# DORMAN POINT ENVIRONMENTAL STATEMENT

VOLUME 3: TECHNICAL APPENDICES  
APPENDICES TO CHAPTER E  
(NOISE AND VIBRATION)

# **Appendix E1: Consultation Correspondence**

**From:** Mick Gent <Michael.Gent@redcar-cleveland.gov.uk>  
**Sent:** 02 December 2020 14:02  
**To:** Young Youn  
**Subject:** [External] RE: Noise assessment approach - proposed developments at Dorman Point / Foundry / Lackenby / Long Acre / Steel House sites

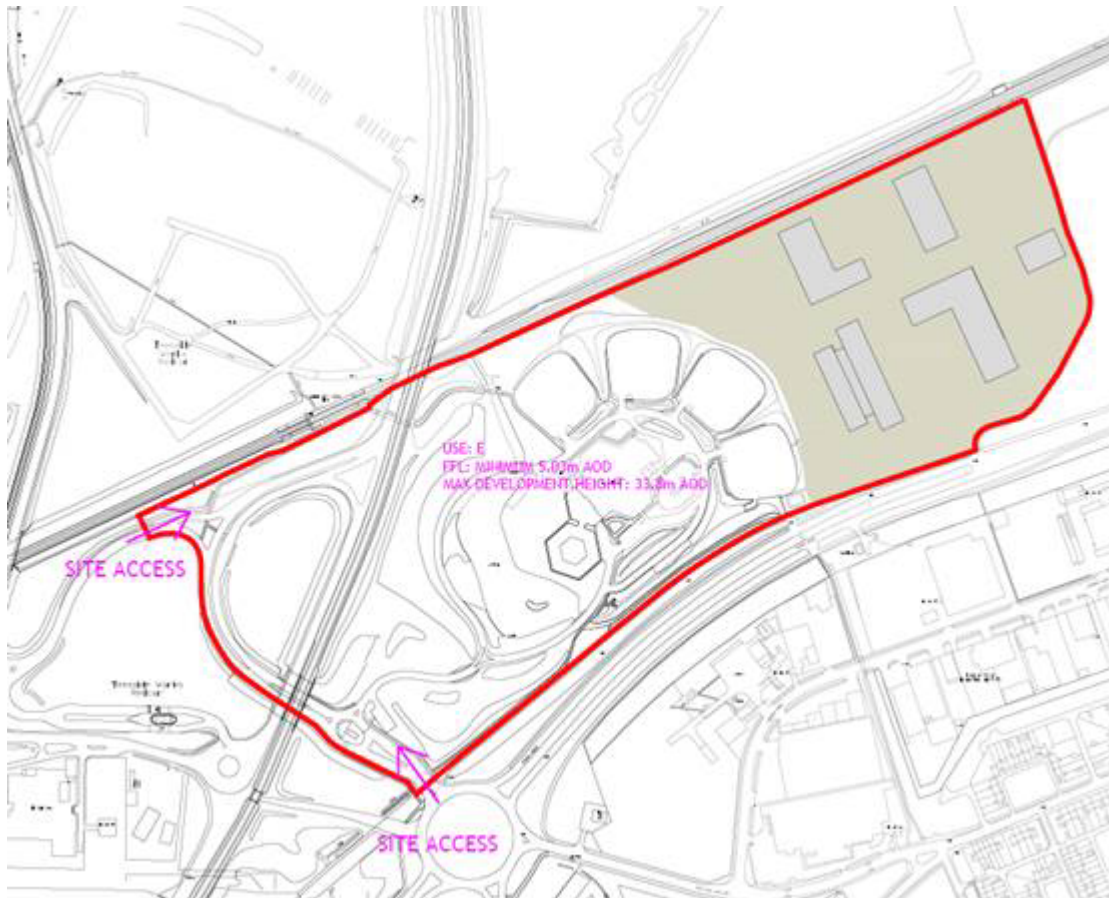
We have daily update on this proposal. Attached image below shows the existing office building and the proposed buildings on the eastern side of the site boundary.

It is our understanding that the area shown below in grey is the actual development locations, although the site boundary does include the existing office building.

This application is for new office buildings. Does this change your response? As I thought, there may have been bit of misunderstanding of the application.

Hi Young  
my only comment is that you should assume any plant will be facing the nearest NSR from the new development.  
regards

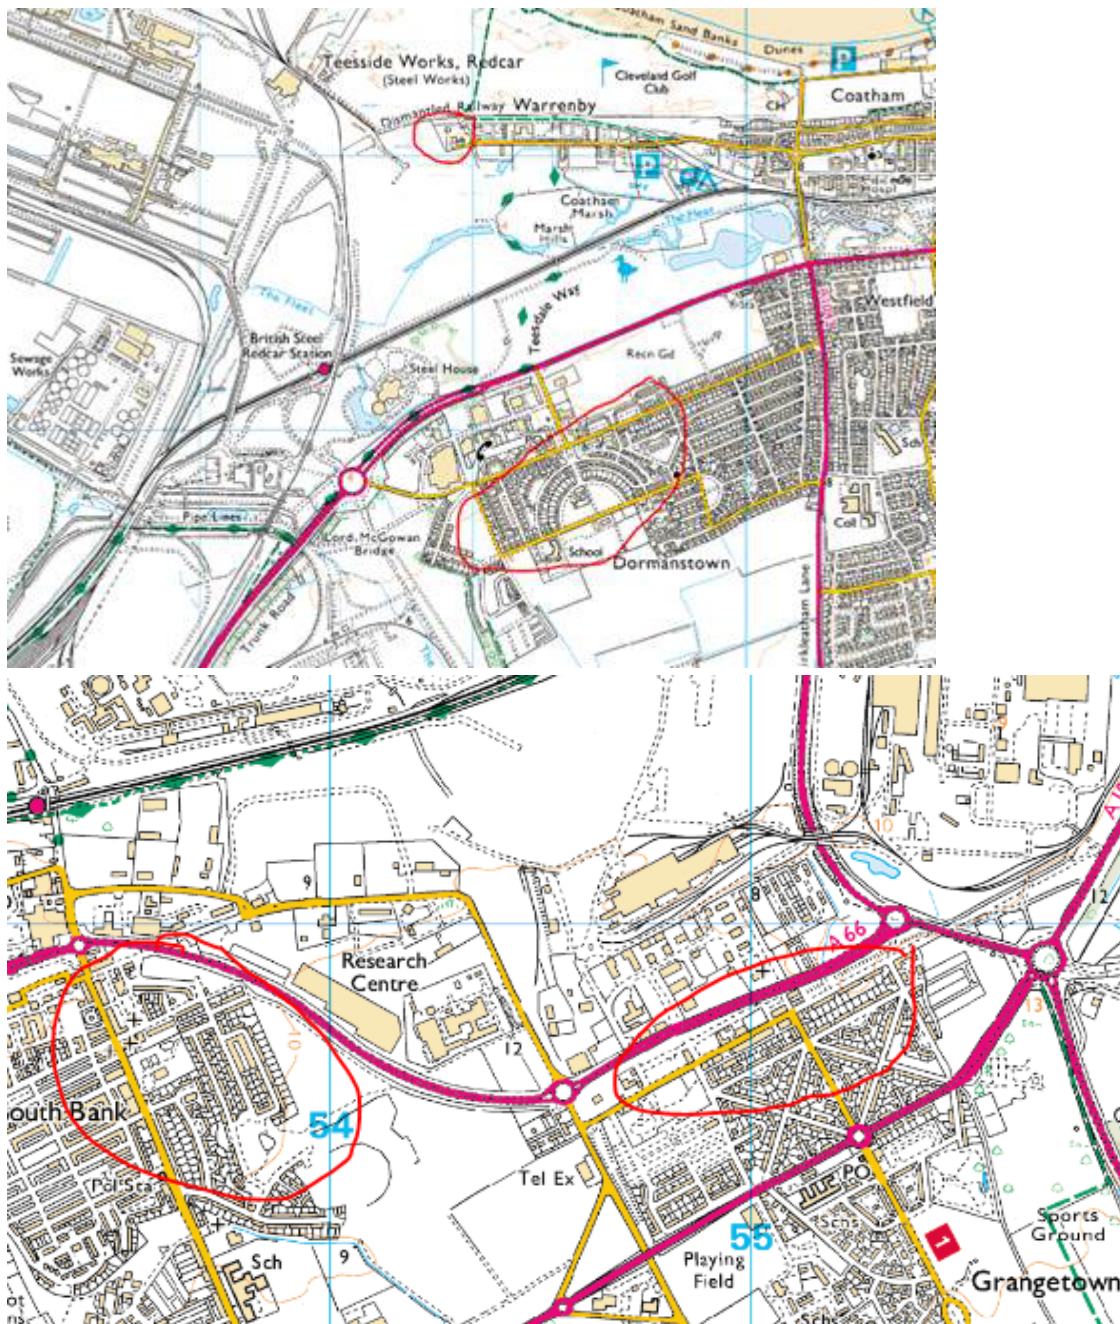
Highlighted closest residential properties circled in red below.
